**APPLICATION FOR PERMISSION
UNDER SECTION 16 OF
THE TOWN PLANNING ORDINANCE
(CAP.131)**

For Official Use Only 請勿填寫此欄	Application No. 申請編號	A/TL-PS/694
	Date Received 收到日期	14 JUL 2023

**Re.: Planning Application Nos.: A/YL-PS/694
Fung Ka Wai, Yuen Long**

Registered Man-made Features within Site

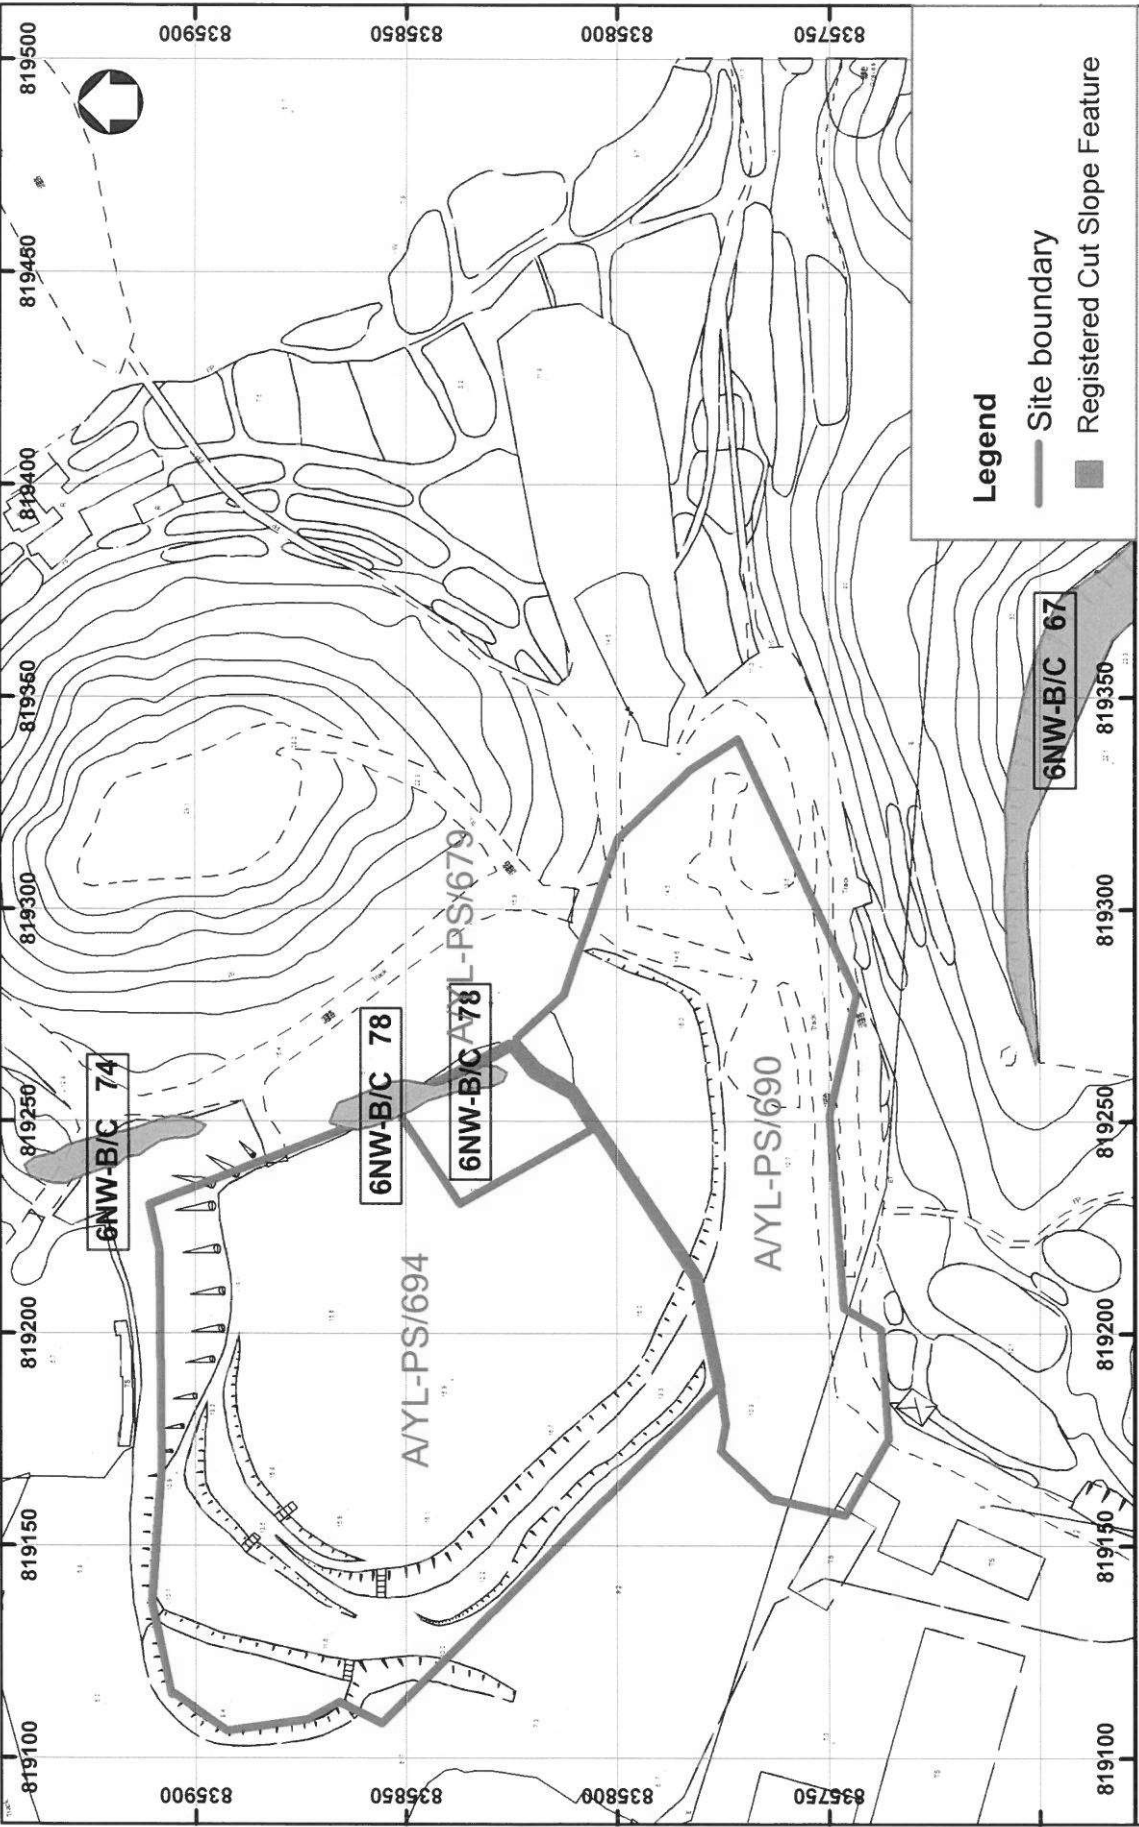
GEO's comment From Ms. Celia Yang dated 13 November 2023	Our response
(i) The site boundary shown in the figures of the GPRR is different from that of the application site. Please ask the applicant to clarify the discrepancy and revise the GPRR accordingly.	(i) Please find attached the revised Figure 1-5 for the site boundary of the application site.
(ii) We note that from the GPRR that ground investigation works will be carried out to investigate the ground conditions at a later stage, and that further assessment on the site/ground conditions will be conducted and submitted to the Buildings Department.	(ii) Noted.
(iii) As noted in the GPRR, a number of unregistered slopes were observed within/adjoining the application site. The applicant should identify the unregistered slopes which are pertinent to the proposed development and review the geotechnical feasibility of the proposed development accordingly. The applicant should also clarify whether further geotechnical assessment for the registered and unregistered slopes, and the proposed upgrading and stabilization measures, if found necessary, will be submitted to the Buildings Department.	(iii) Please be clarified that further site visit and detailed survey will be carried out after site clearance to identify unregistered slopes within/adjoining the application site. GI works would be proposed to assess the registered and unregistered slopes, and the proposed upgrading and stabilization measures if found necessary in the later stage.

According to the available SIMAR reports retrieved from Lands Department and SIS records obtained from Geotechnical Engineering Office (GEO), there is 1 registered geotechnical feature lies within or in the vicinity of the site (see Figure 3). The feature and the responsible lot/party are tabulated below:

Ground Profile at and in Vicinity
of the Subject Application Site

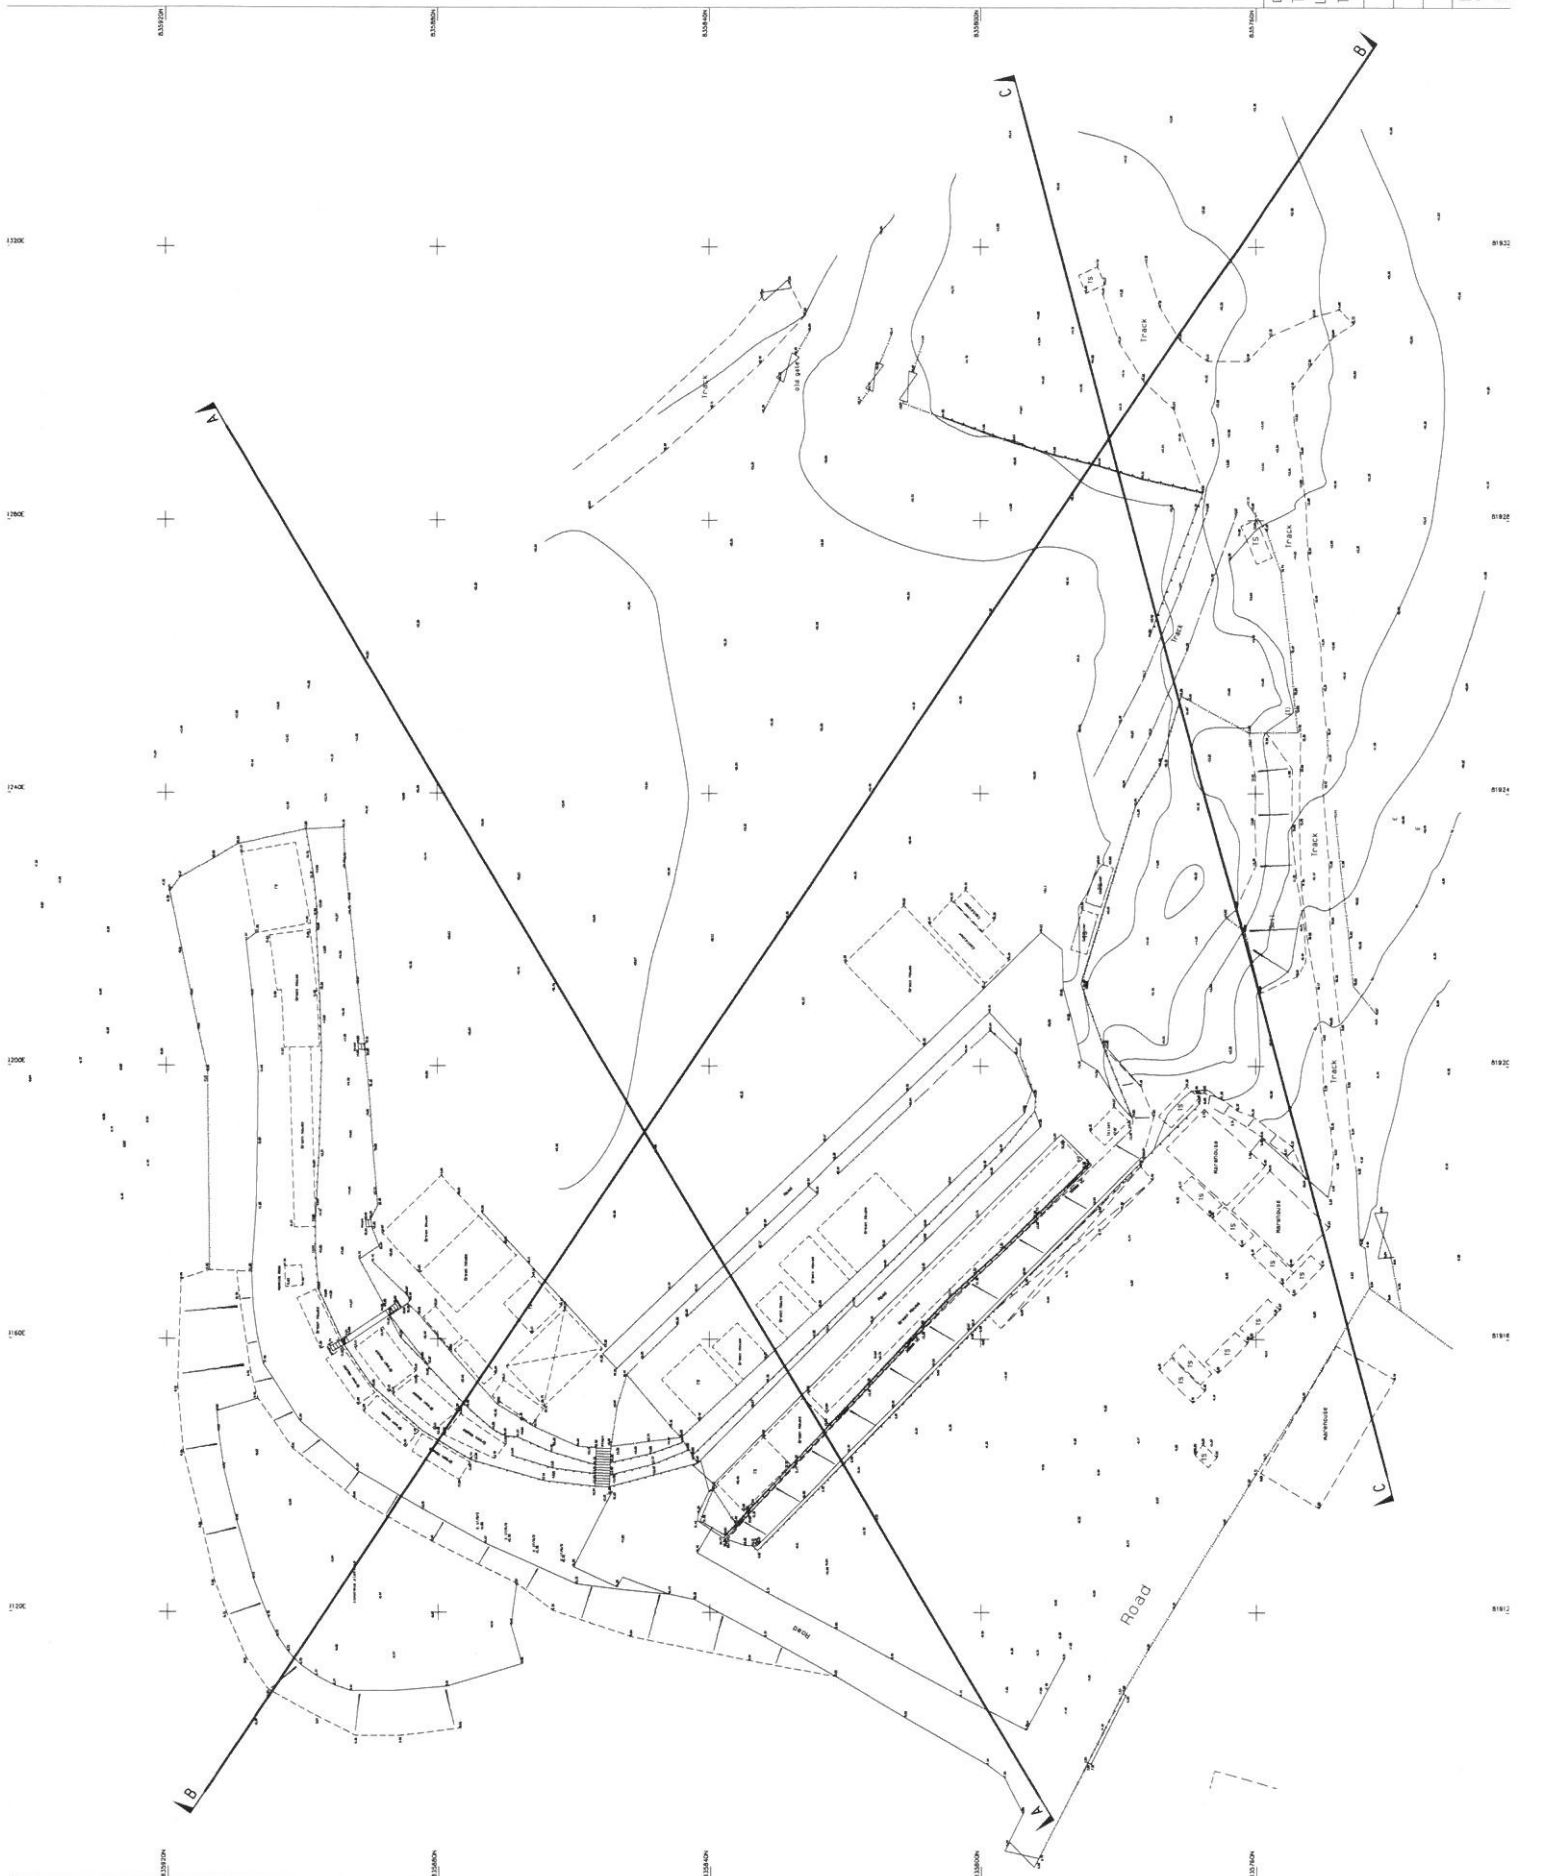
(iv) The applicant should provide section to show the ground profile at and in vicinity of the subject application site.	(iv) Please find attached Appendix E showing the ground profile at and in vicinity of the subject application site.
